York Street Interchange

Public Inquiry
Technical Paper

City Reparo Alternative
Design Proposal

10 November 2015

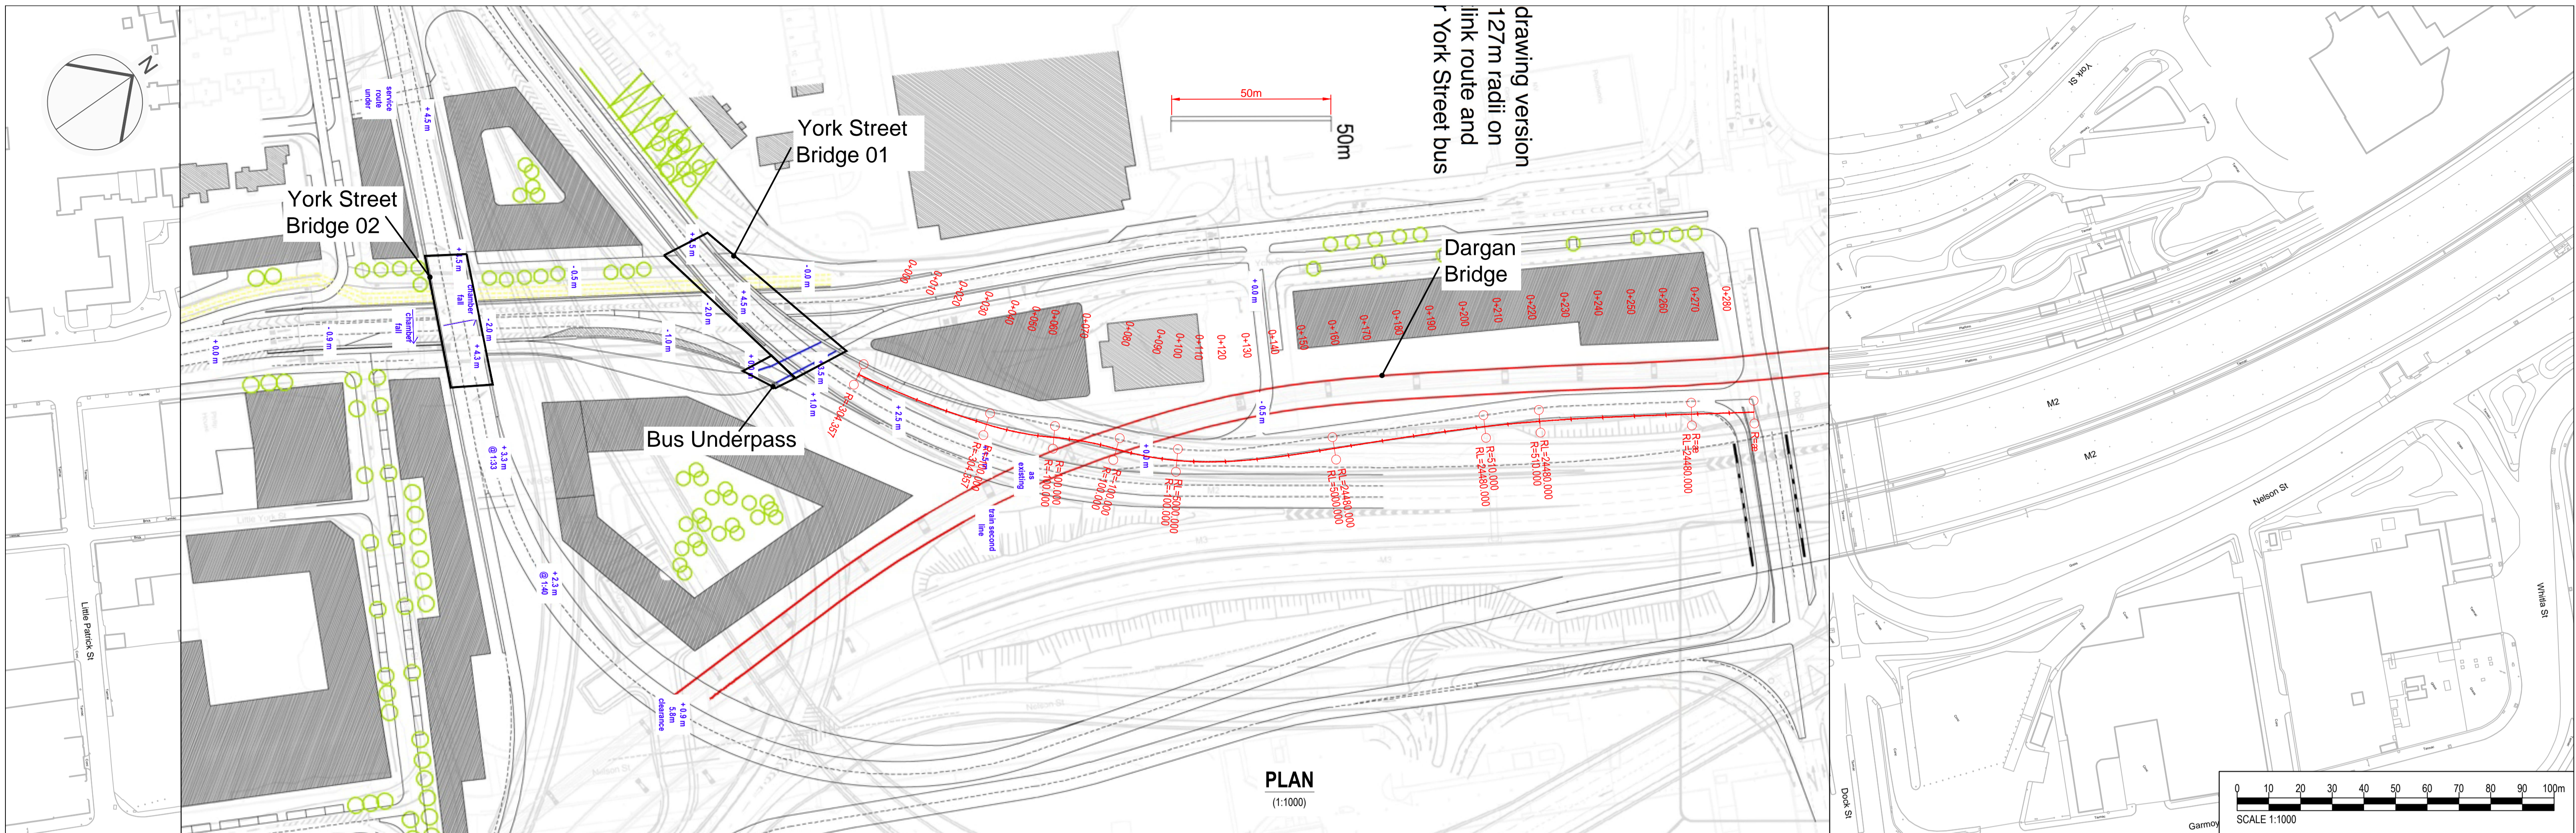
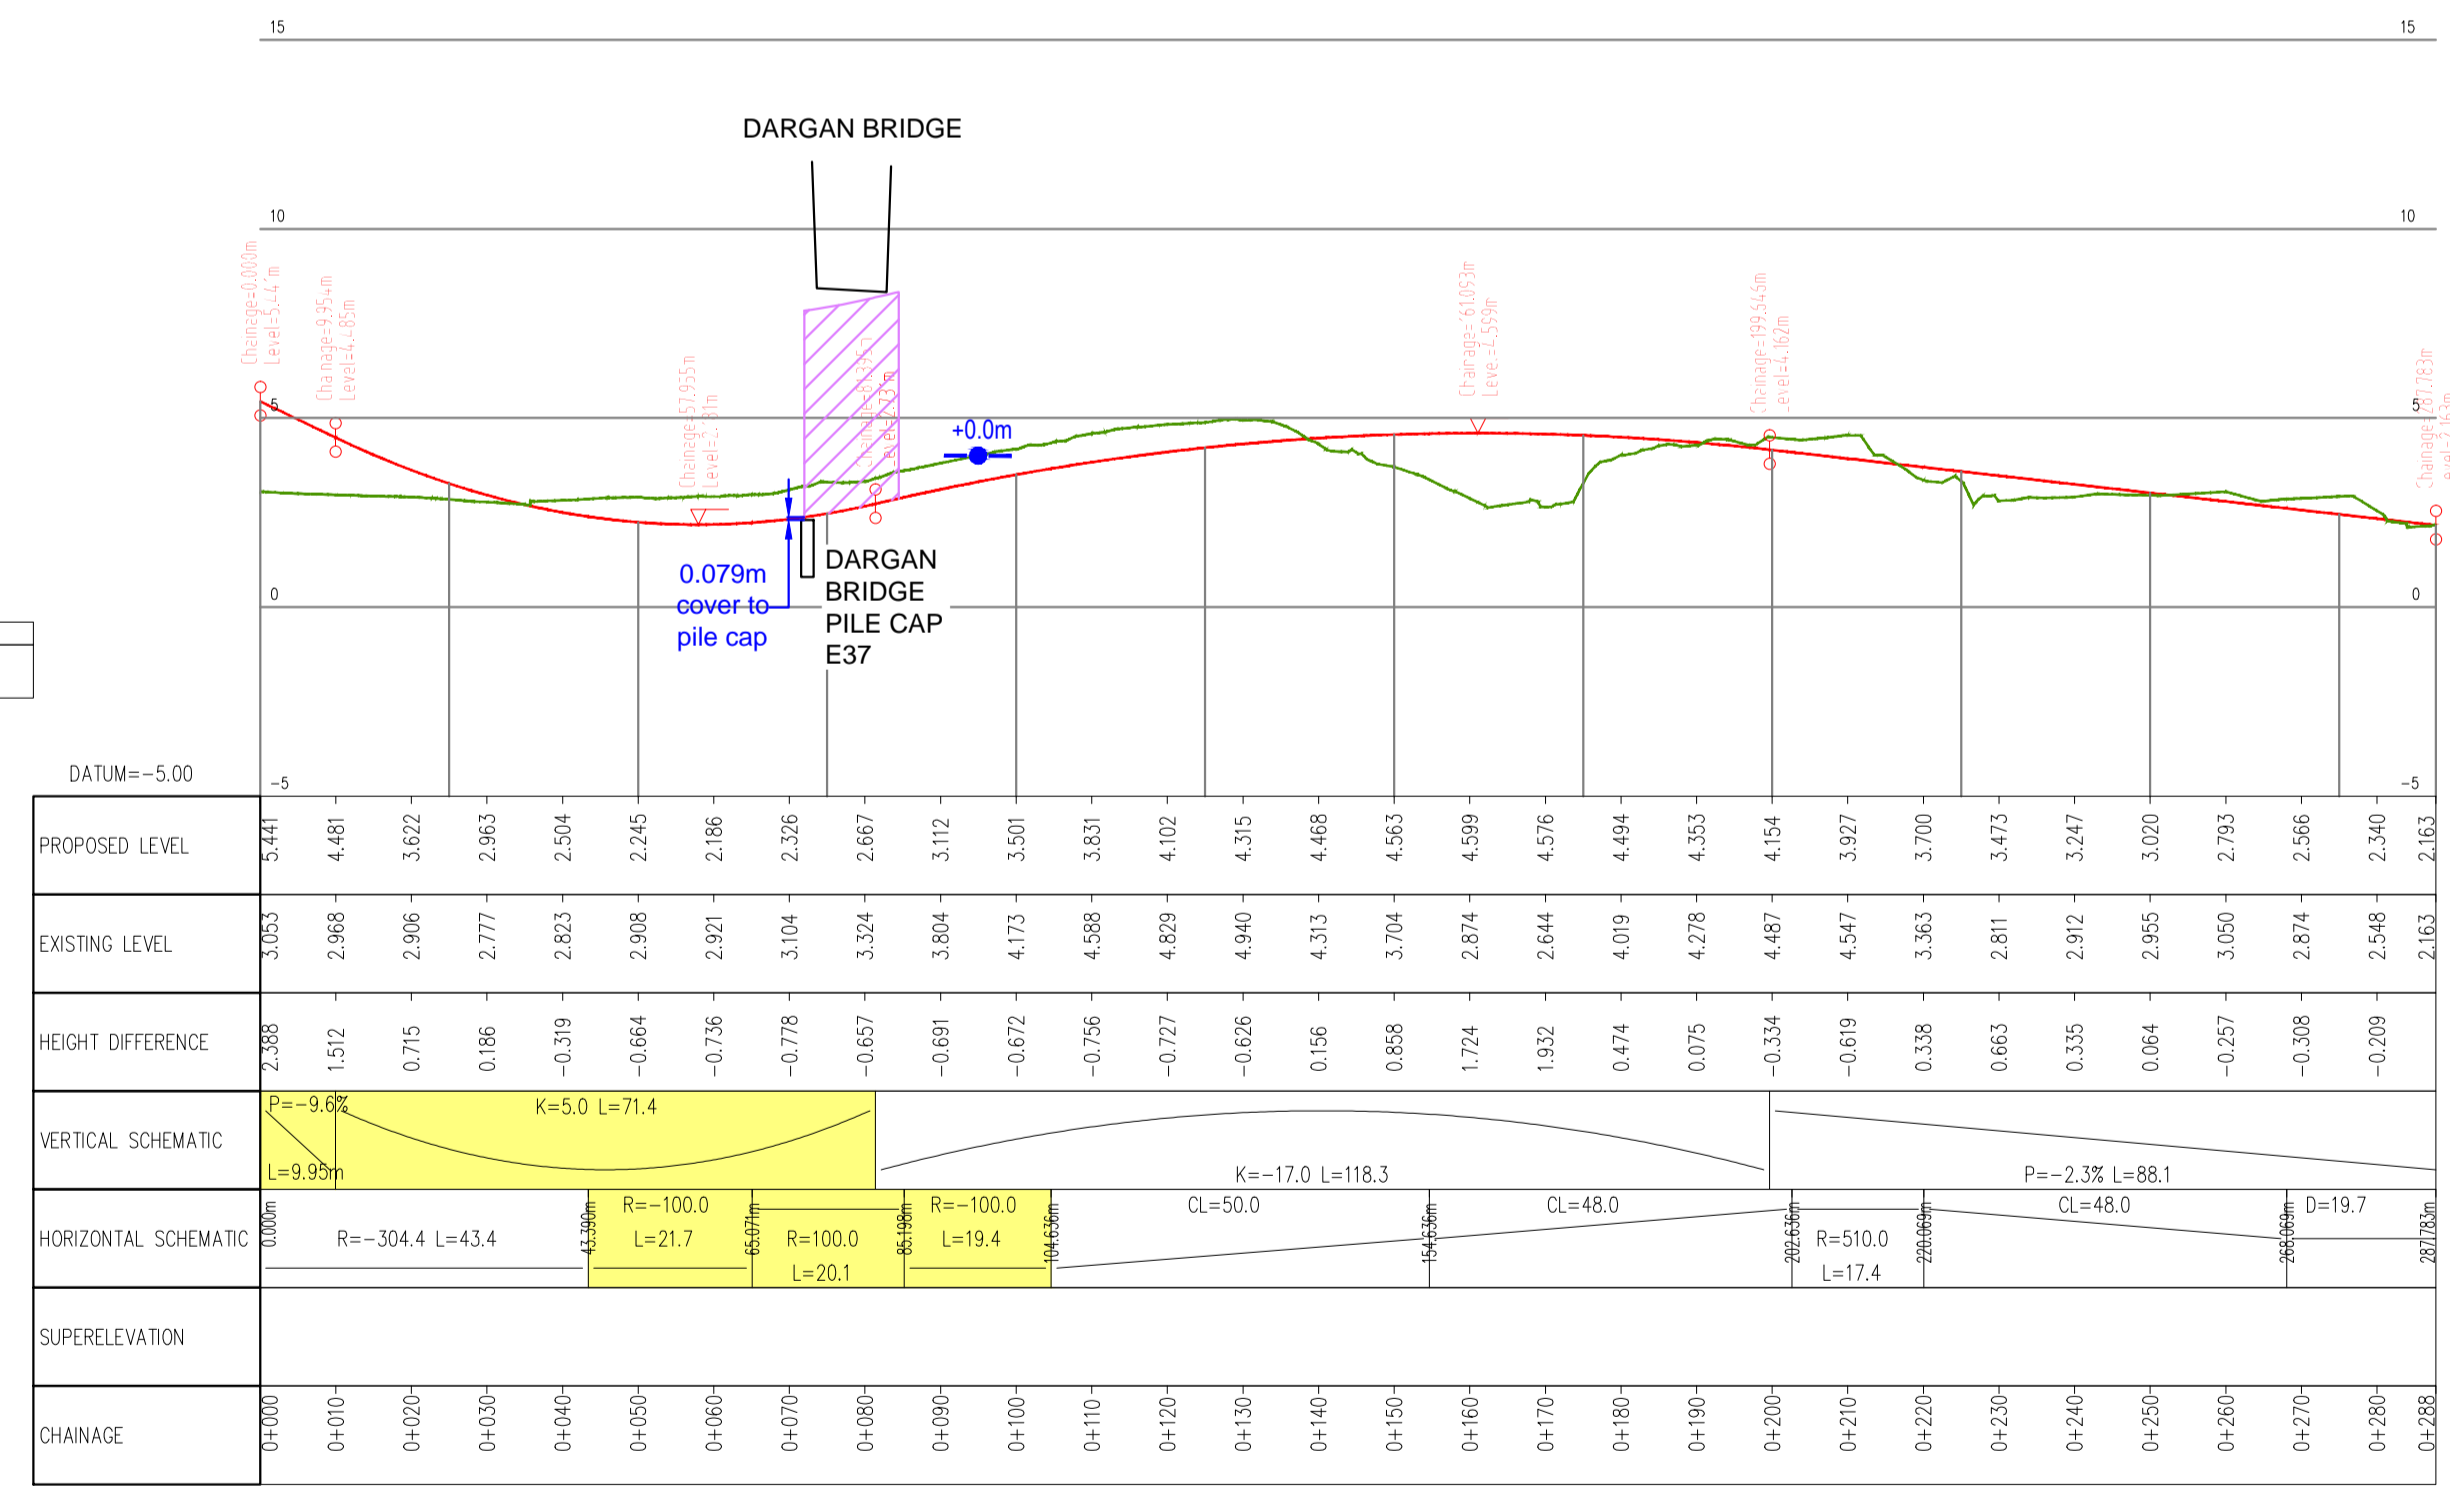
- Having completed a best-fit alignment of the CRP, it would appear that the vertical alignment on the Westlink to Dock Street (and onward to M3) off-slip would clash with the position of the existing foundations of the Dargan Bridge and would therefore be unfeasible.

- Again, an initial review of the CRP highlights that these standards have not been considered when developing the proposals. Taper lengths are below standards, with nosings too short in length and too shallow in angle. Examples of this include the diverge nose on the Westlink to M3 link and the merge nose on the York Street to M2 link. The latter is particularly concerning as there will be a level difference between the merging flows. The alignment of the Westlink to M2 link is likely to be supported either on structure or with a retaining wall at this point and the width of the merge nose does not take account of the presence of a retaining wall and associated vehicle restraint system.

- The CRP includes changes to the Dock Street junction to introduce a segregated loop circuit for Westlink to M3 traffic using widening of the westbound carriageway (and removal of its southern footway). All other through traffic on Dock Street would be unchanged. The junctions at Brougham Street and Nelson Street would require modification to accommodate this change, particularly to redirect non-motorised users to the northern footway on Dock Street at the Nelson Street junction. The resultant loss of the southern footway is therefore not in keeping with the scheme objective to maintain access for pedestrians and cyclists.

- The width of the single Westlink to M3 loop at Dock Street appears limited to not more than 4m, which again, in the event of an incident, leaves no additional available width to drivers to manoeuvre around a stopped vehicle. As there appears to be no feasible option to provide additional width without loss of lanes for through traffic on Dock Street, this would be a significant vulnerability in the CRP.
